Item7a MTC Resolution No. 4537, Revised. Major Project Advancement Policy: Stage Gate Evaluation and Recommendations for Transbay Joint Powers Authority - the Portal Project

2015 DTX draft SEIR

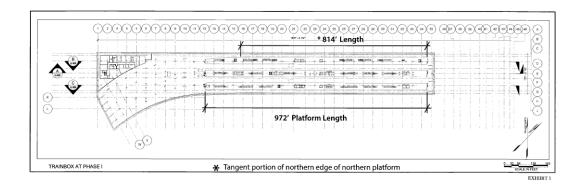
The last diagram in the letter shows that **the shortened platforms cannot possibly accommodate a 1,350-foot long Brightline West double-consist** even though the box <u>as currently constructed</u> is 1,530 feet long.

EXHIBIT 1

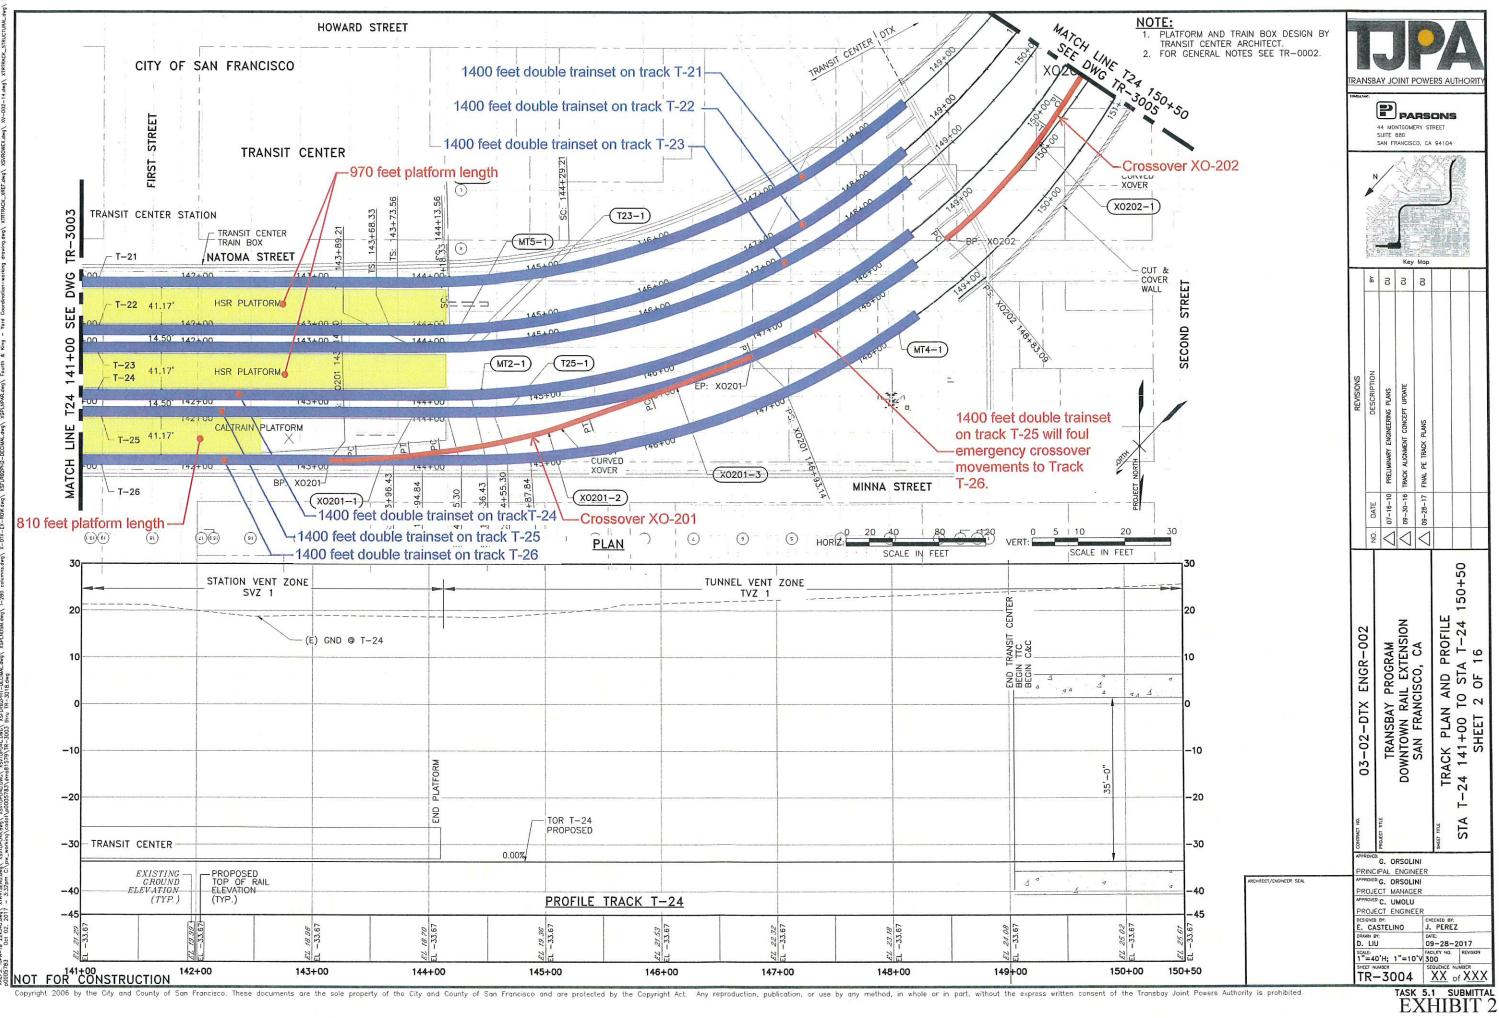
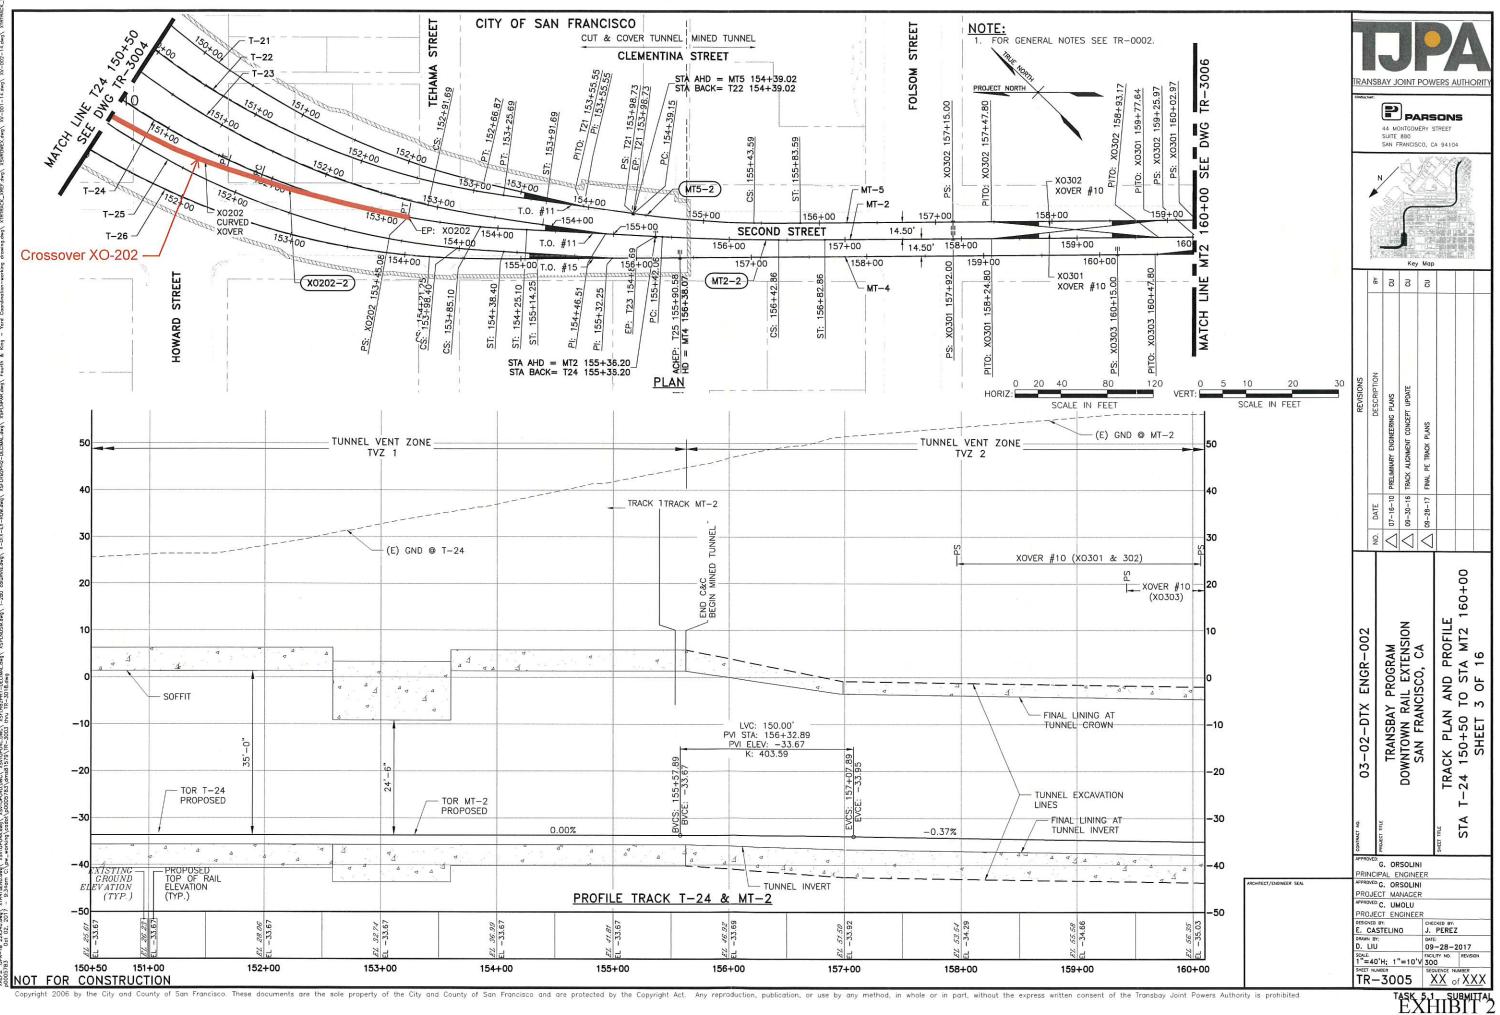
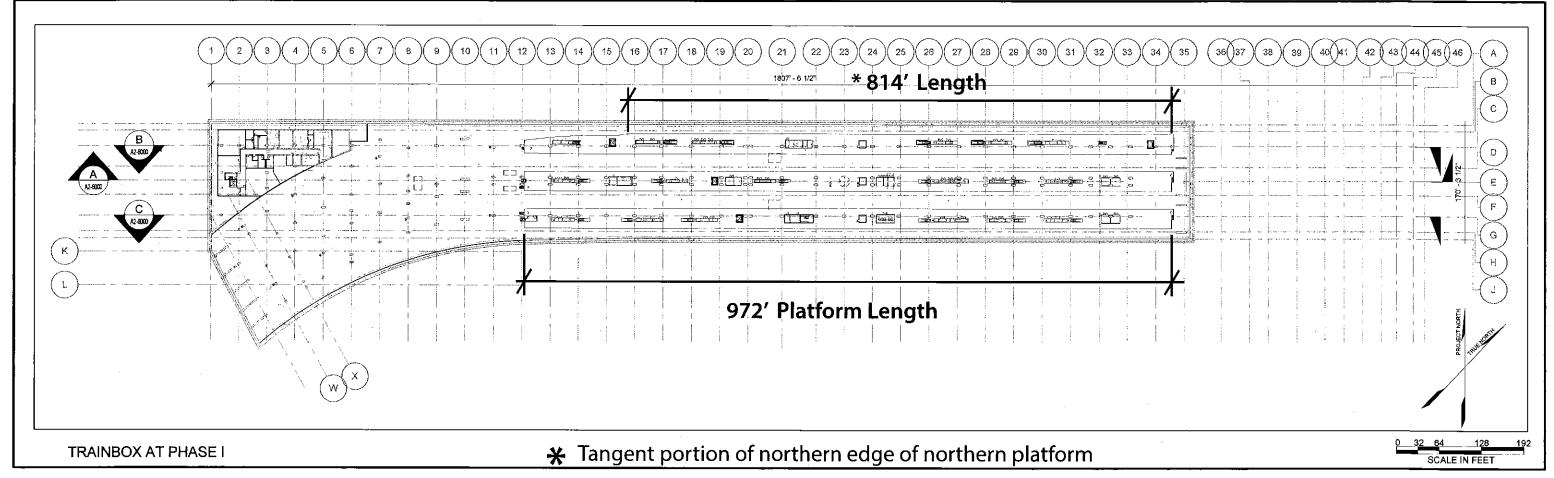
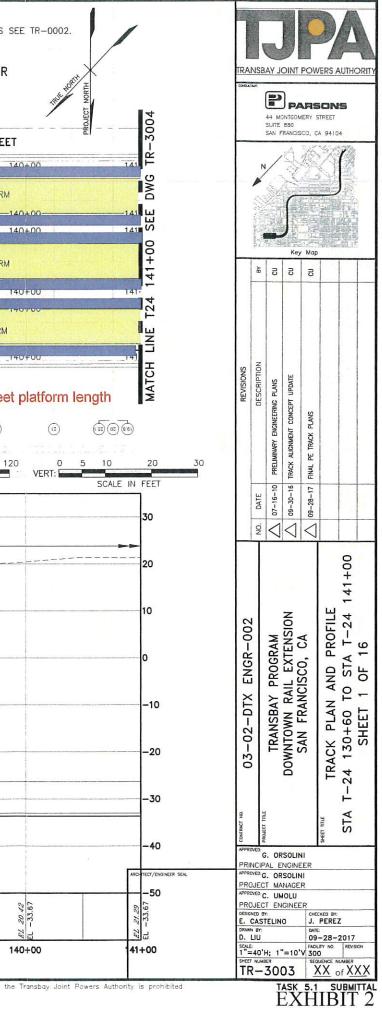
These platform lengths are the longest constructible lengths within the existing train box, which terminates at Beale Street (see Exhibit 1). The TJPA has determined that under these platform lengths (without the train box extension) a double-length 400-meter-long CHSRA train can access any of the six platform faces in the transit center without fouling an adjacent platform track under normal operating conditions. A CHSRA train stopped on platform face T-25 will foul the emergency crossover to access platform face T-26 in an emergency scenario where the turnout near Station 156+00 is out of service (see Exhibit 2); however, CHSRA has confirmed and understands this limitation and accepts this condition.

1) Train Box Extension

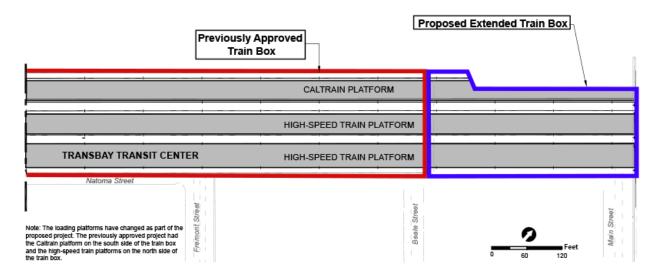
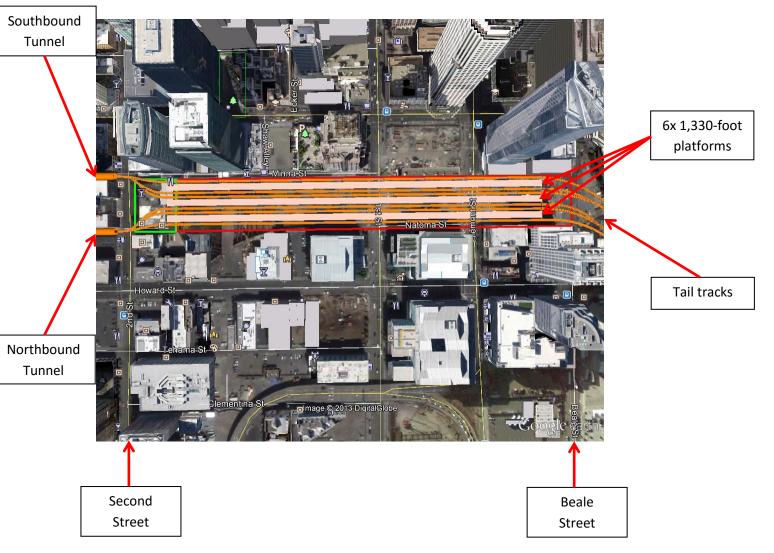
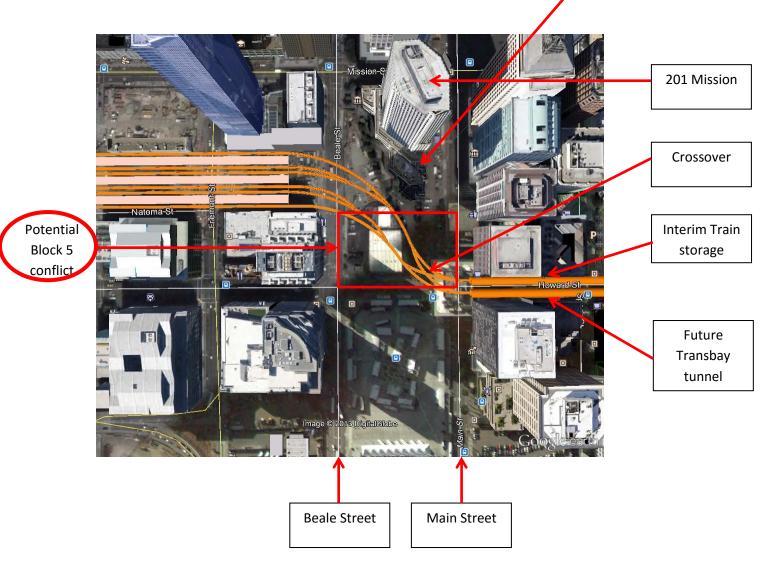
- The train box extension design violates SB916 (2003) codified in Streets & Highways Codes section 30914(22) (<u>http://law.justia.com/codes/california/2011/shc/division-17/30910-30922/30914</u>) by failing to provide any kind of engineering solution for a future East Bay extension

- The proposed Caltrain storage is insufficient to enable Caltrain to vacate the 4th & King railyard until after relocation to Oakland.

The SEIR should consider an alternate DTX alignment which would enable platform lengthening by extending the train box one block west (towards 2nd Street) while simultaneously providing a viable connection to a Transbay tunnel. This alignment would also eliminate conflicts with the 201 Mission building and enable a 6th full-length through platform (total 3 eastbound and 3 westbound platforms).

This alignment would eliminate the need to demolish the 201 Mission podium structure.

2) Widened throat structure

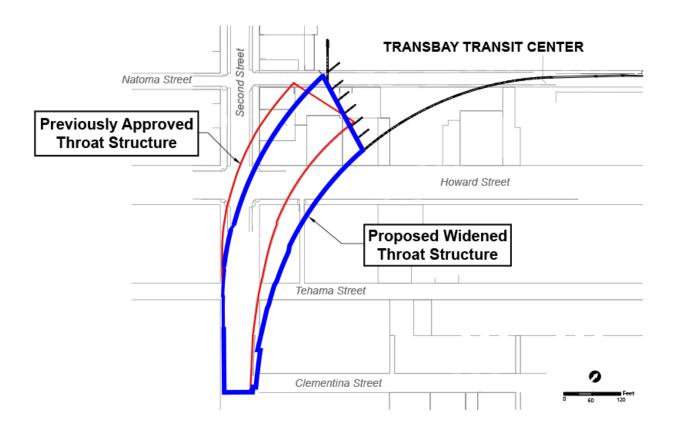
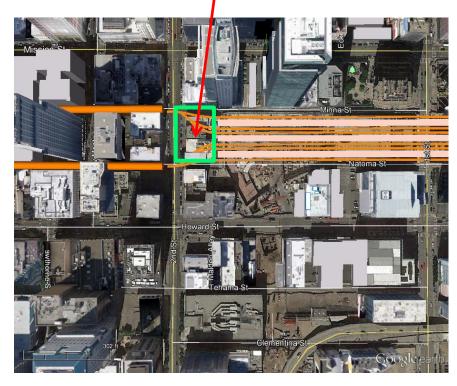
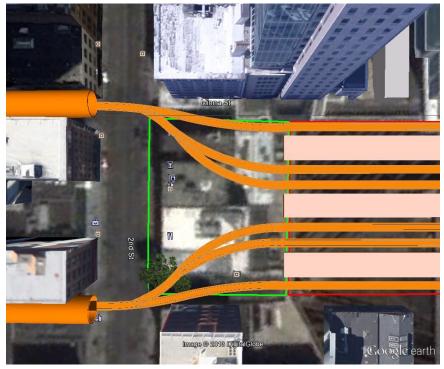
The SEIR proposes a widened approach to the Transbay Center train box via a massive cut & cover structure that will impact numerous properties as far south as Clementina Street. Construction costs are expected to run into the hundreds of millions and will result in massive circulation and noise impacts on the adjacent neighborhoods for many years.

The SEIR should consider an alternate DTX alignment and construction technique that would limit impacts to a small number of buildings on 2nd Street between Minna and Natoma. <u>There would be no additional surface impacts in SOMA north of Townsend</u>.

3) Tunnel design

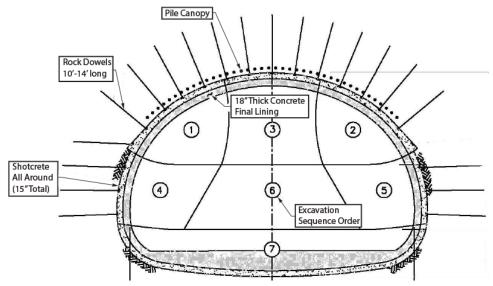
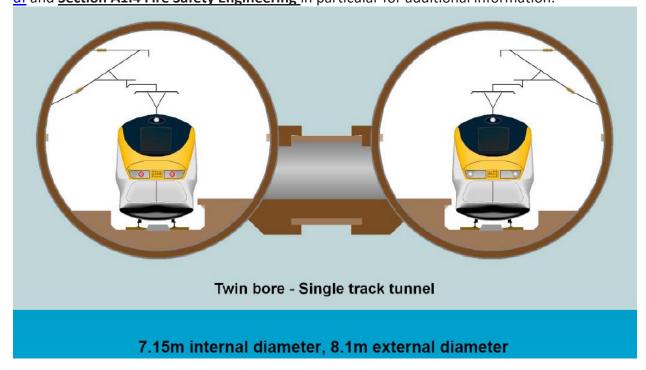
The current DTX design contemplates the construction of a 3-track sequentially excavated tunnel without any apparent plans for the evacuation of a train travelling on the middle track. This is of particular concern with High Speed trains which have a single door per carriage.

The SEIR should consider a twin-bore tunnel design with cross-passages for emergency evacuation (similar to the Central Subway) and a ventilation system designed to eliminate any requirement for vent/evacuation structures north of Townsend. Please refer to Appendix A (Tunneling Studies) in the HS2 Final Report <u>http://www.railwaysarchive.co.uk/documents/HS2_RouteEngineeringStudyAppendices_2010.p</u> df and **Section A1.4 Fire Safety Engineering** in particular for additional information.

4) Fourth and Townsend Underground Station location

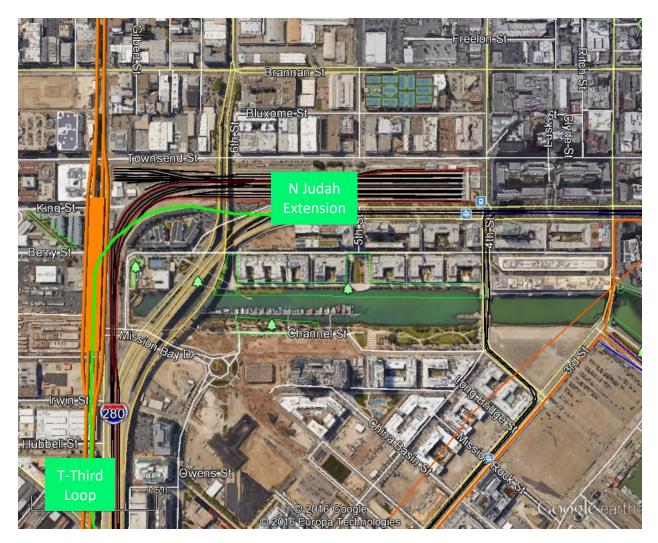
It is unclear how a relocated Caltrain station on Townsend could possibly accommodate the ridership demand from Mission Bay including UCSF, AT&T Park and the proposed Warriors Arena.

The SEIR should consider relocating the Townsend station to 7th Street and providing connectivity to the Central Subway via an extension of the N line connecting to the Mission Bay loop via 16th Street. This station should be designed to accommodate the Grand Boulevard at a later date.

5) 7th Street Tunnel Stub Box

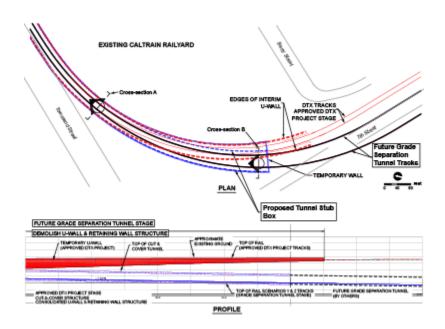
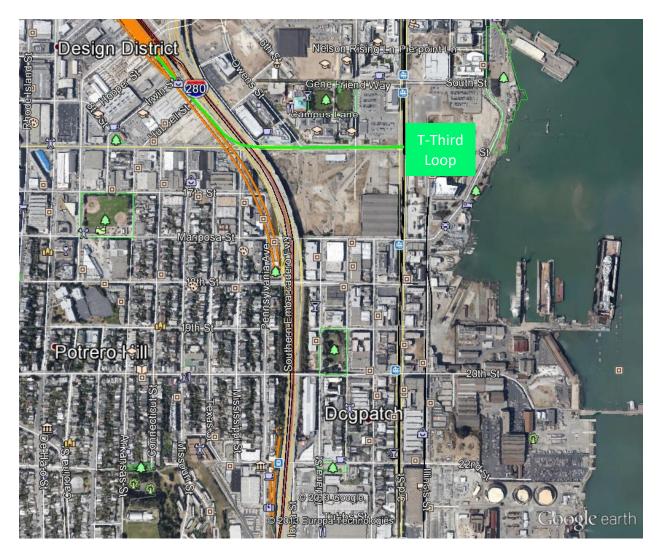
The SEIR proposes to terminate the DTX on 7th Street with a "tunnel stub box" designed to accommodate a future 16th Street grade separation.

The SEIR should consider a direct connection to the Planning Department's Pennsylvania Avenue RAB study alternative. This would achieve 16th Street Grade separation as soon as Caltrain operations are relocated to the Transbay terminal and would save hundreds of millions by eliminating cut & cover structures @ 7th & Townsend

6) Turnback Track impacts on 16th Street grade crossing

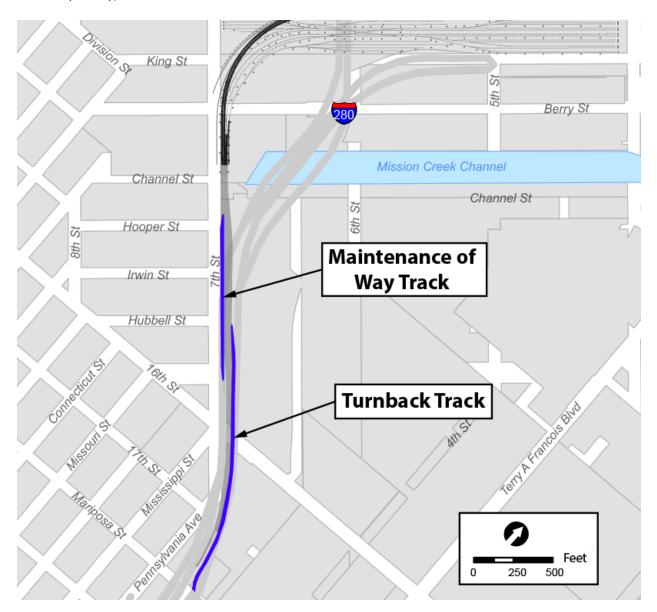
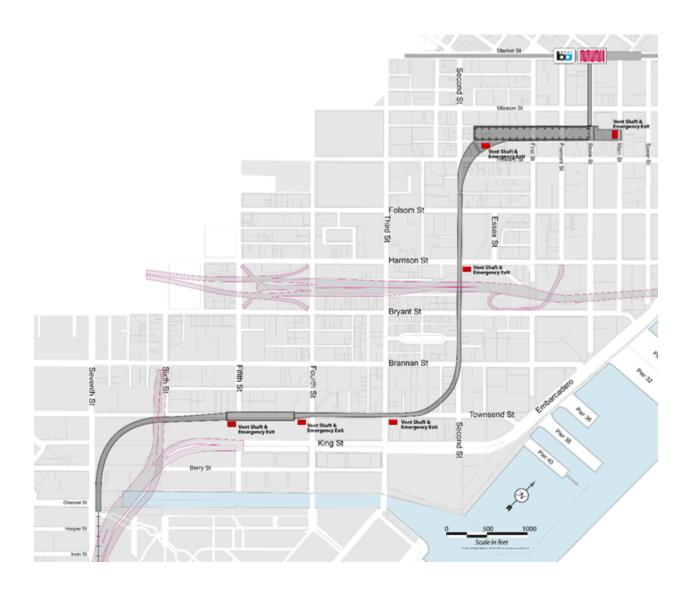
The SEIR proposes the addition of two additional tracks on 7th Street, including a turnback track across 16th Street, thereby increasing gate downtime for each train crossing by an additional 10 seconds (10 minutes per day).

The SEIR should consider a direct connection to the planning department's Pennsylvania Avenue alternative (see recommendation #5 above) and turn trains around further south. The SEIR should also consider the abandoned tunnel #1 for storage.

7) Alignment conflict with AB3034 (San Jose to Transbay in 30 minutes)

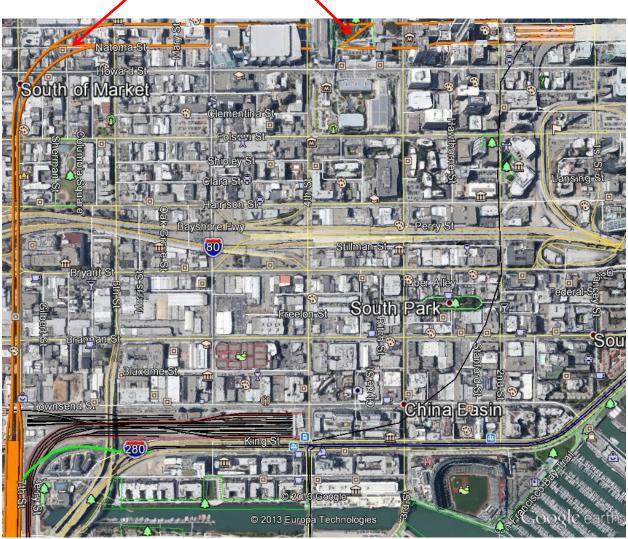
The current DTX alignment consists of 3 sharp curves each with a maximum speed of 25 MPH which extend the travel time between 7th Street and the Transbay Terminal by an additional 3 minutes.

The SEIR should consider an alternate alignment designed to enable an 80 MPH approach to the Transbay Transit Center.
